DEKALB PLANNING AND ZONING COMMISSION AGENDA
Monday, August 4, 2025
6:00 P.M.

1. **Public Hearing** – A petition by Amoco Hossen, represented by DVG Team, Inc. to rezone the property located at 802-810 S. 4th St. from the “GC” General Commercial District to the “PD-C” Planned Development Commercial District to allow a gas station/convenience store.

RE: 802-810 S. 4th St. – Approval of the rezoning from the “GC” General Commercial District to the “PD-C” Planned Development Commercial District; Preliminary and Final Development Plan (SE corner of S. 4th St. and Taylor St.).

AMOCO GAS STATION
Site Plan

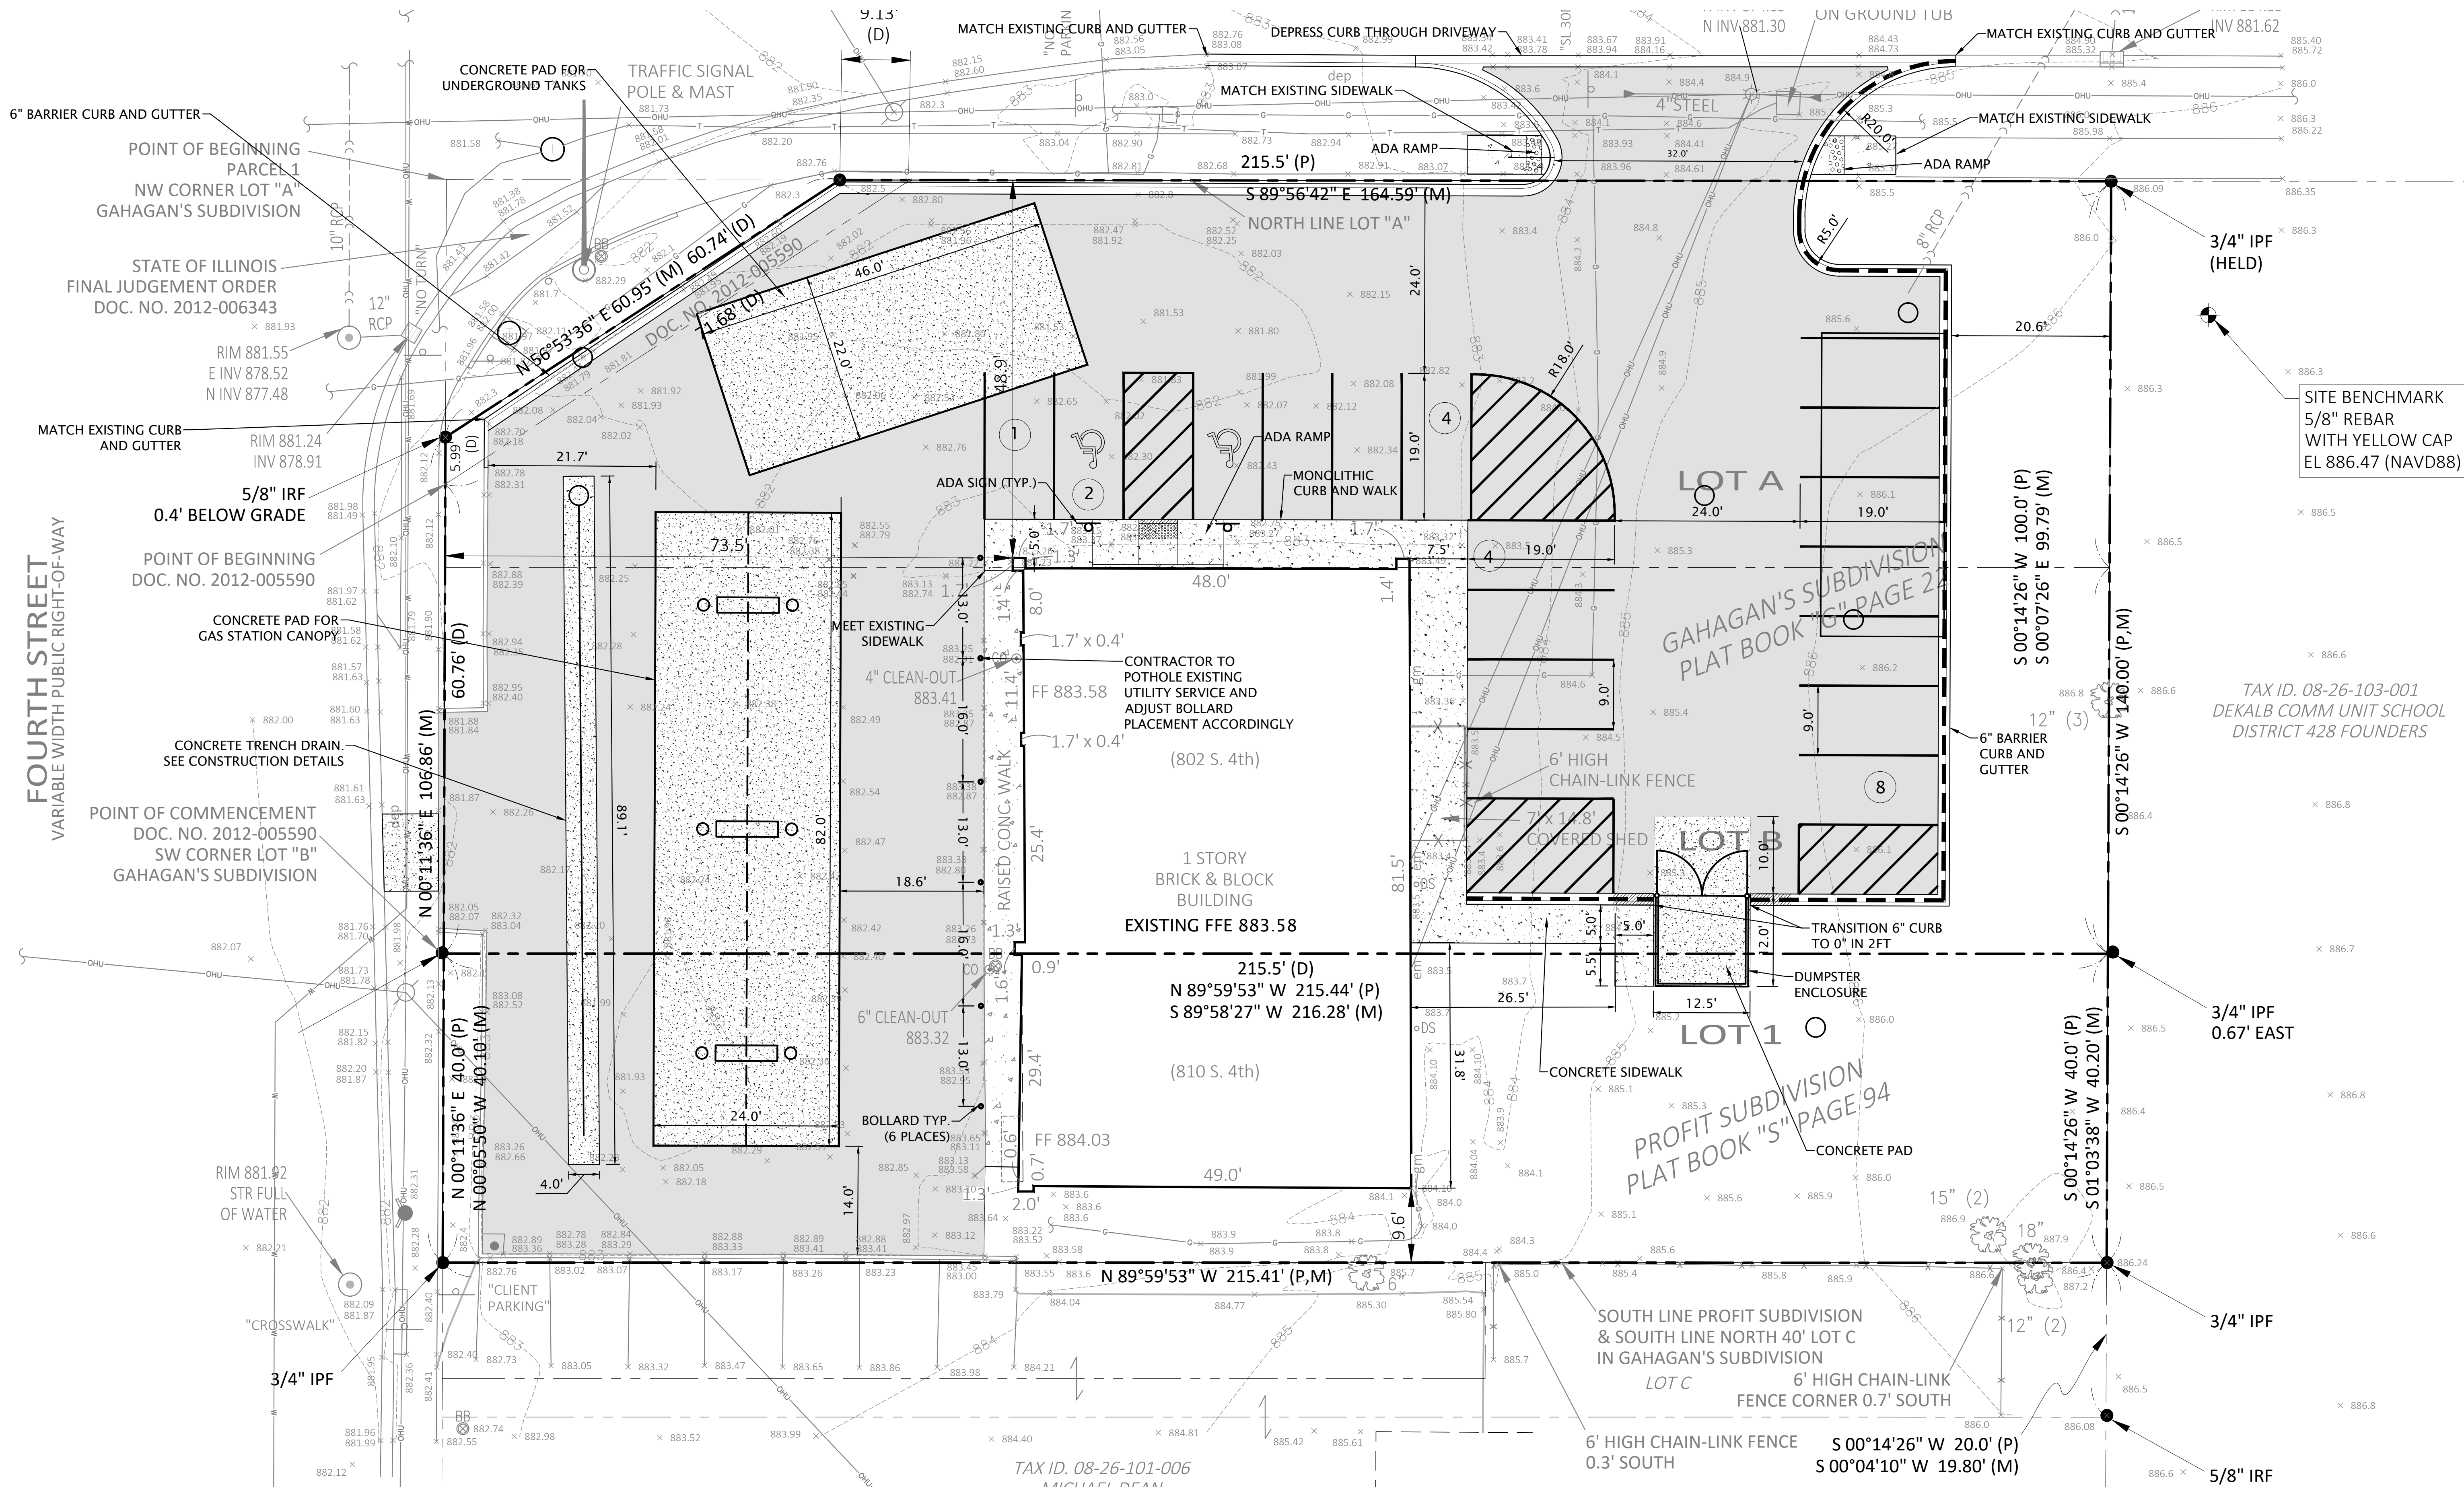
2. It is noted that the truck template touches the utility pole at the west access and the edge of the canopy just north of the west middle section.
Response: The turning template has been refined to demonstrate that the fuel truck can navigate the movement without contacting the utility pole. The canopy is elevated enough that the fuel truck will pass under the canopy.

5. The northern access should be widened to at least 32' face-to-face of curb to facilitate the complicated movements.
Response: The northern access point onto Taylor Street has been widened to 32 FT.

6. Two ADA parking signs are required in lieu of the single one shown on Sheet C103. The fine amount in the City of DeKalb is \$350.
Response: An additional ADA parking sign is now shown on Sheet C103. Depending on the final building facades, the developer may choose to install both signs on the building. The construction details have been revised to note the increased fine amount, if the developer installs fine placards below the signs.

7. The dumpster should be moved 8'-10' south to provide room for vehicles in the southern stalls to back out and form vehicles to turn around if all the stalls are occupied.

1. There is a maximum site coverage of 70% in the "PD-C" District. Please provide this calculation.
Response: This calculation is now shown on Sheet C103 alongside the Site Data Table. This development exceeds the 70% threshold and does not provide 4 or more components with which to earn a site coverage escalator per the UDO. As such, one of the remaining development variances we are requesting is related to site coverage.

Response: The parking lot pavement has been expanded 10 FT to the south and two "striped" spaces are now shown to allow a reversing vehicle space to turn without contacting the enclosure.
